MODBAR TECHNICAL BULLETIN

#14

Tap Handle Bushing – Espresso and Steam Handle

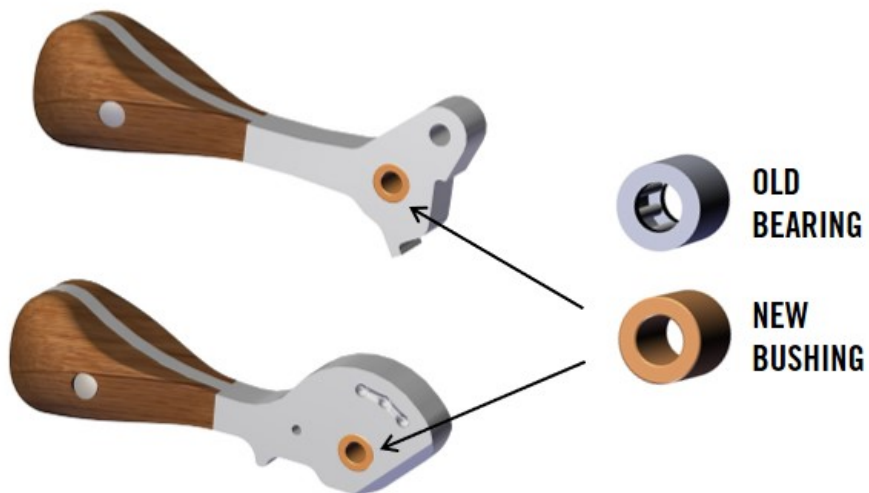
All espresso and steam actuator handles will now have a brass bushing set opposed to the previous roller bearing design. It will still be important to lubricate the brass bushing and inspect the shoulder bolt during regular scheduled preventive maintenance.

This change started with serial # 2215.

It is now possible to order actuator handles with the updated bushing.

We do not suggest retrofitting the bushing update in old handles.
